CITY OF ALBUQUERQUE

RE: **6505 Canavio NW, SAD 228**
Pad Certification for lot 6 Block 8 Unit 18
Engineers Stamp Date 9/6/16 (D10D003K5)
Certification Date 10/11/16

DRAINAGE AND TRANSPORTATION INFORMATION SHEET (REV 09/2015)

ENGINEER'S SEAL	LOT 6 BLOCK 8 UNIT 18 VOLCANO CLIFFS SUBDIVISION	DRAWN BY JDG
DAVID SOULE NEW MEXICO REGISTERED PROFESSIONAL ENGINEER 14522	GRADING AND DRAINAGE PLAN	DATE 10-18-2016
10/19/16 DAVID SOULE P.E. #14522	Rio Grande Engineering 1606 CENTRAL AVENUE SE SUITE 201 ALBUQUERQUE, NM 87106 (505) 872-0999	SHEET # 1 OF 1 JOB #

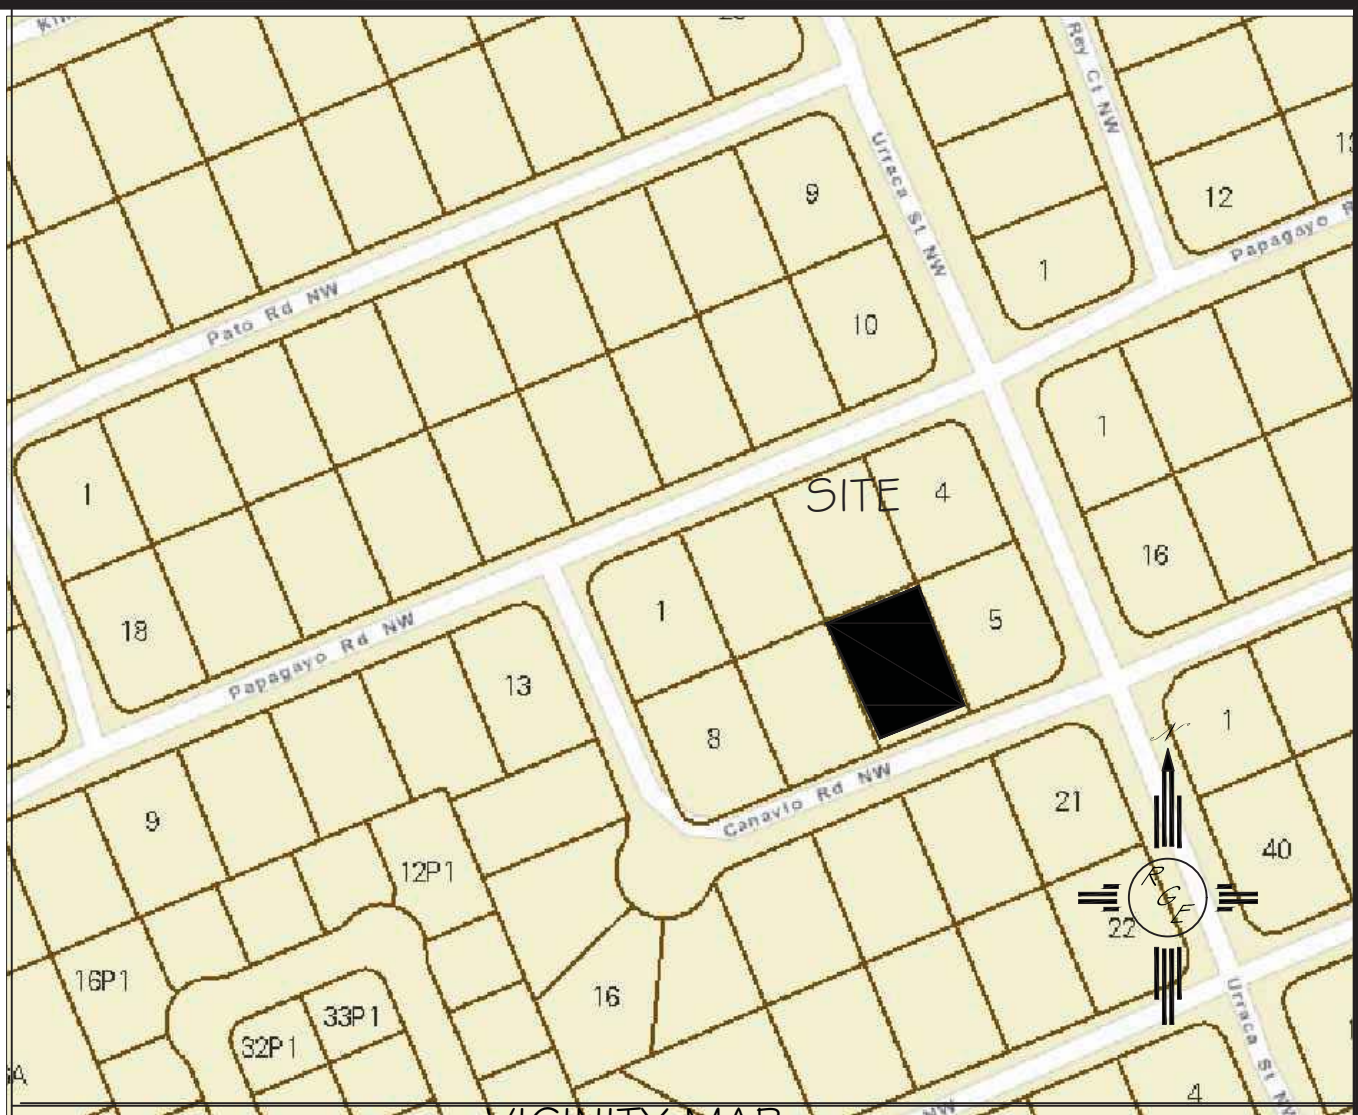
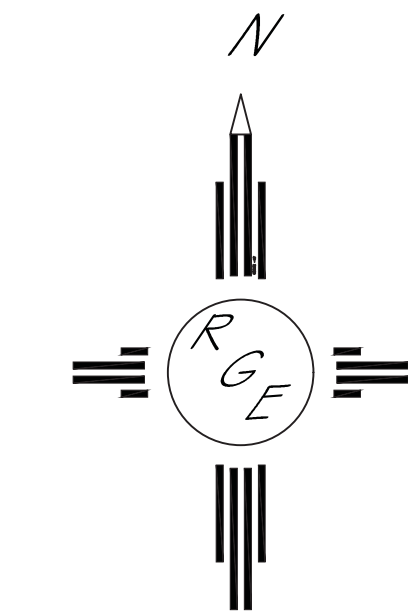
Based upon the information provided in your submittal received 12/27/2016, the above referenced Certification for 6505 Canavio Pl. NW is acceptable for building permit.
